Description:	
ELEVATIONS	
Project:	
GRENELL TOWER GRENELL RD, LONDON, W11 1TG	
Drawn By:	Date:
bd KVL	30.09.14
Scale:	
1:30@A3

<b>harley</b>	
HARLEY HOUSE BROOKLANDS PARK FARNINGHAM ROAD CROWBOROUGH EAST SUSSEX TN6 2JD Tel: [REDACTED]	
Drawing No:	Rev:
C1059-216	-

Project: <b>GRENFELL TOWER GRENFELL RD, LONDON. W11 1TQ</b>
Drawn By: <b>bd KVL</b>
Date: <b>30.09.14</b>
Scale: <b>1:30@A3</b>

<p>HARLEY HOUSE BROOKLANDS PARK FARNINGHAM ROAD CROWBOROUGH EAST SUSSEX TN6 2JD Tel: [REDACTED]</p>	<p>Drawing No: C1059-335 Rev: -</p>
---	---

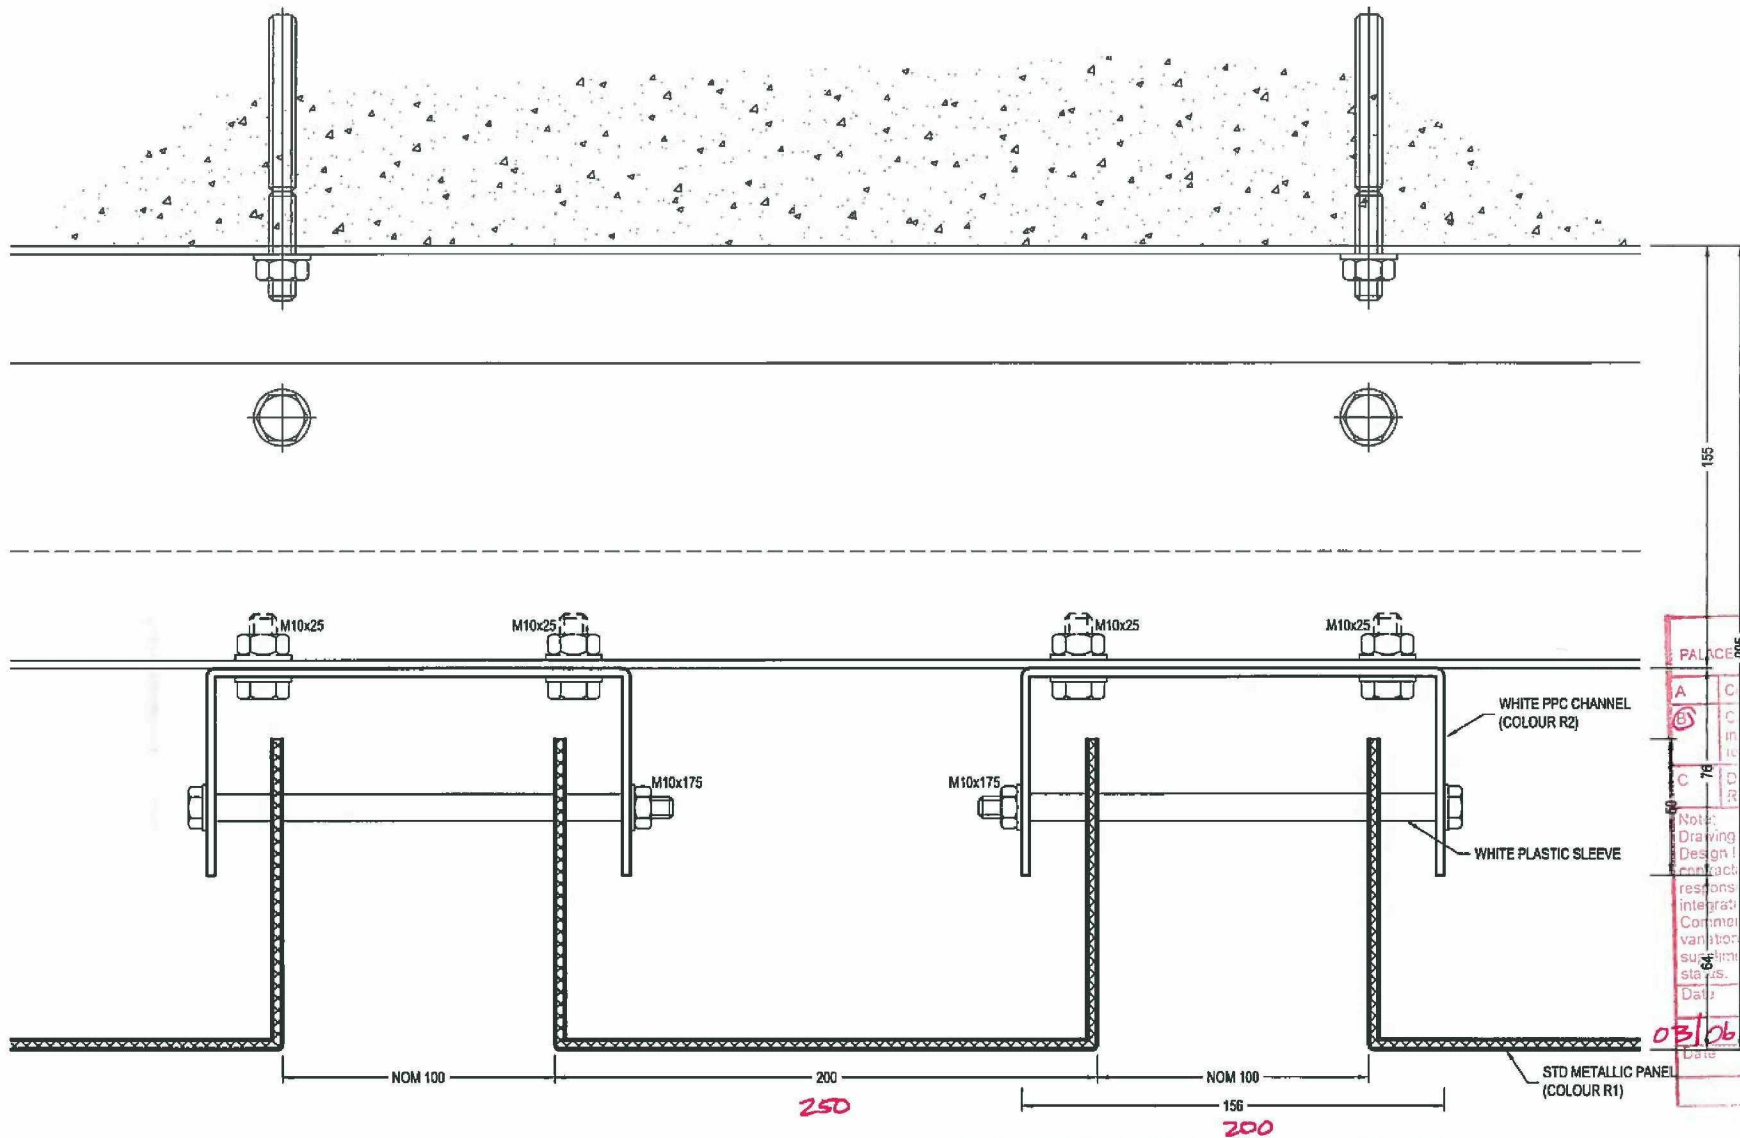
IS IT POSSIBLE TO INCREASE THE SPACING ON THESE  
 AS INDICATED SO THEY WILL LOOK MORE LIKE PANNING  
 COLOUR SET (?)

<b>harley</b>	
HARLEY HOUSE BROOKLANDS PARK FARNINGHAM ROAD CROWBOROUGH EAST SUSSEX TN6 2JD	
Drawing No:	Rev:
C1059-336	-

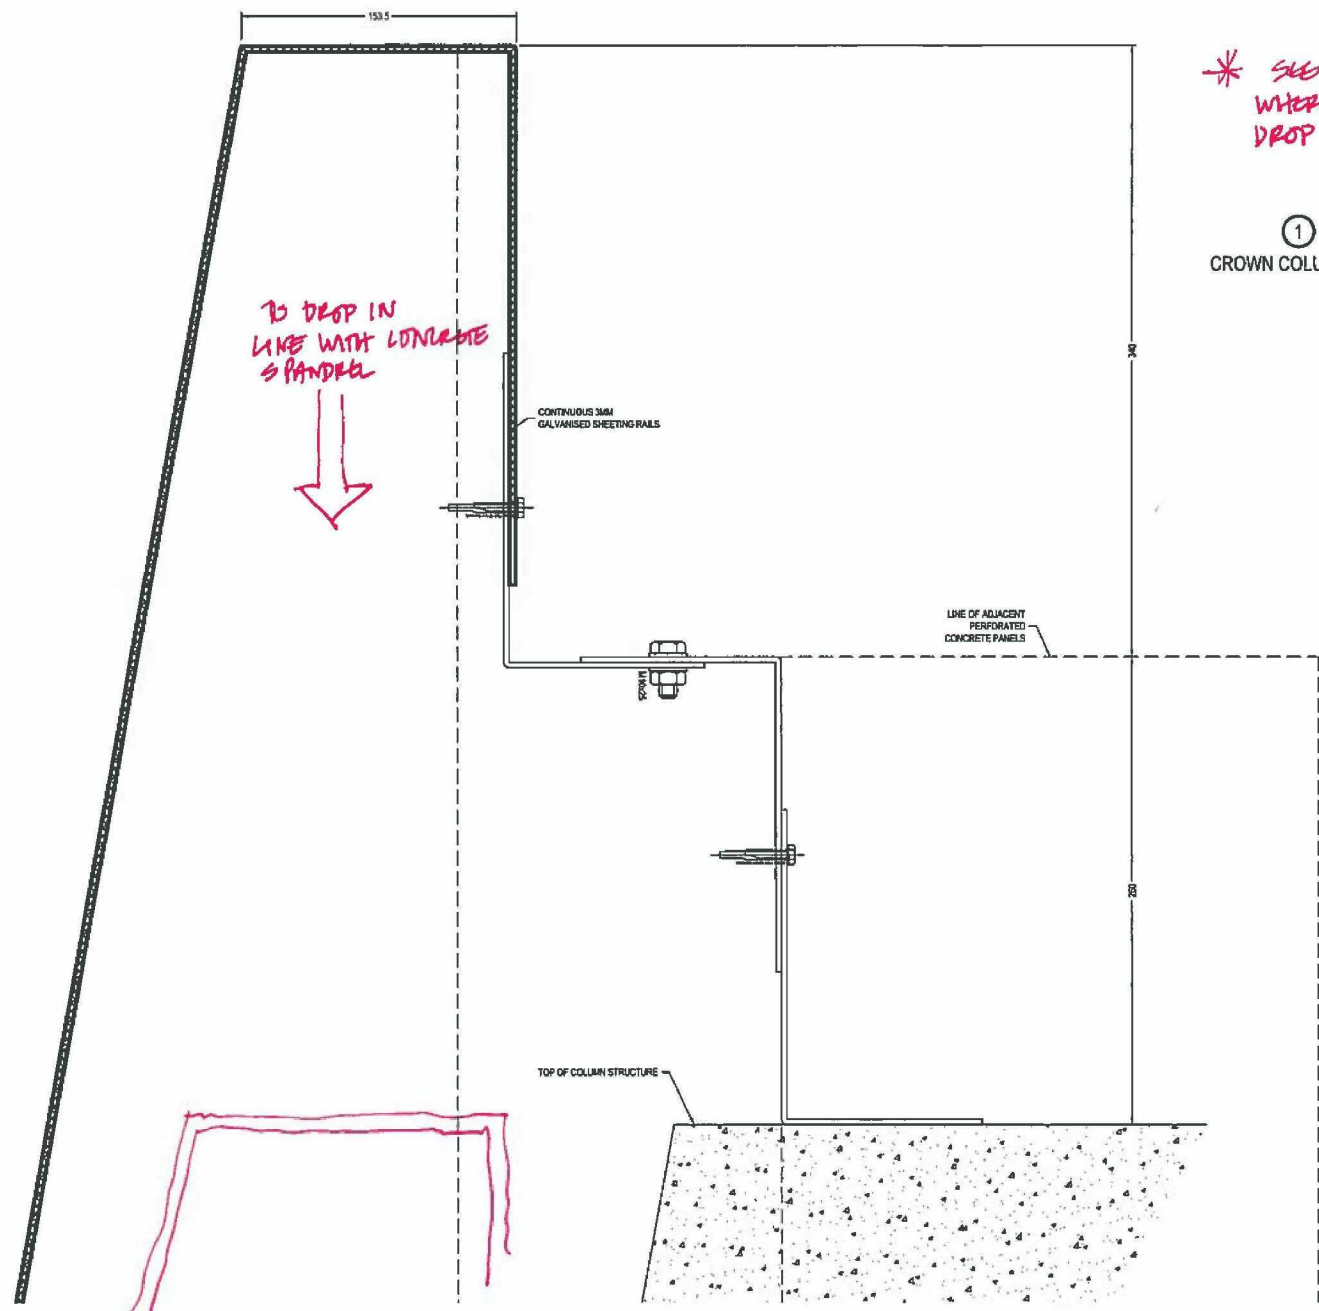
\* SEE COMMENTS ON C1059-334 WHERE CLIENT HAS REQUESTED DROP IN CROWN HEIGHT.
